SERVICE CAMPAIGN BULLETIN

CAMPAIGN REF : 019
TITLE : Update secondary fuse box access cover label
DOCUMENT # : 11 P 001
AFFECTED VEHICLES : 12C Coupe

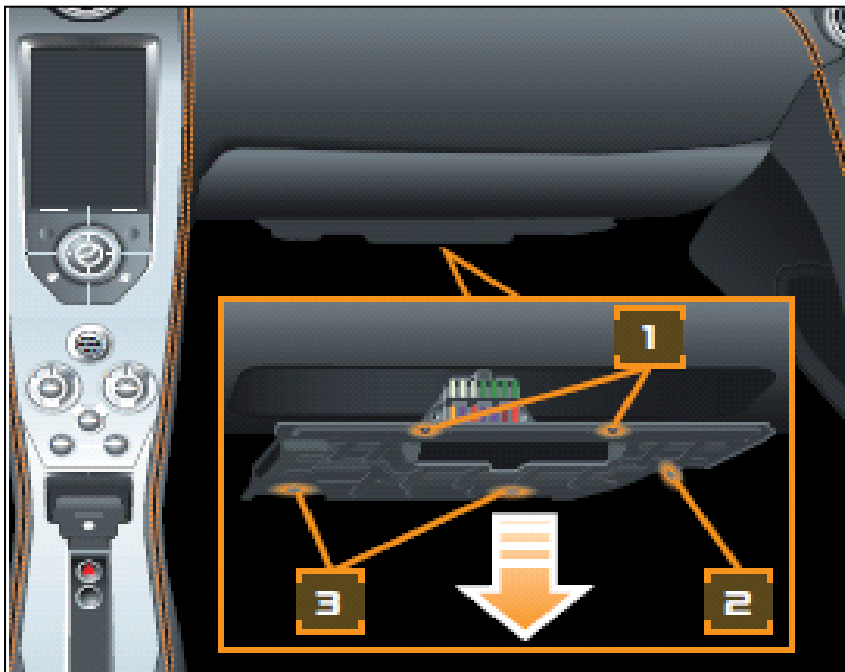
1. Remove main fuse box access cover (1) by lowering the closing panel below the dashboard on the passenger side. Remove the side fixing clip (2) and the two clips at the rear (3).

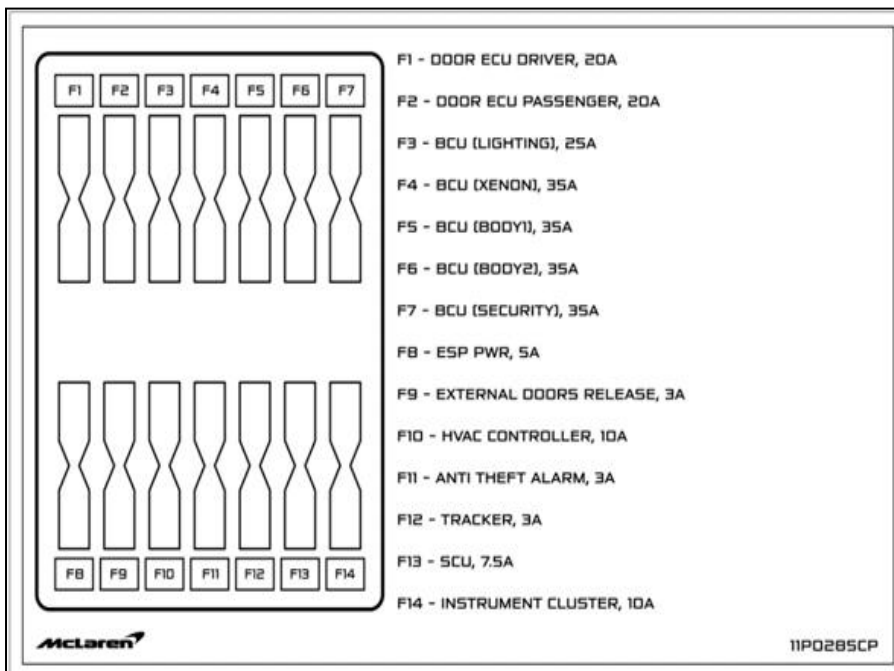
SITUATION : Quality Engineering at McLaren Automotive have produced an amended secondary fuse box label for affected vehicles. The existing secondary fuse box label states the driver and passenger door ECU fuses are 25A. However, vehicles fitted with an updated wiring loom, should state 20A fuses are needed. The updated label corrects this issue.

- Fit new fuse label to the foam pad attached to the underside of the main fuse box access cover. An image of the new label is outlined below.
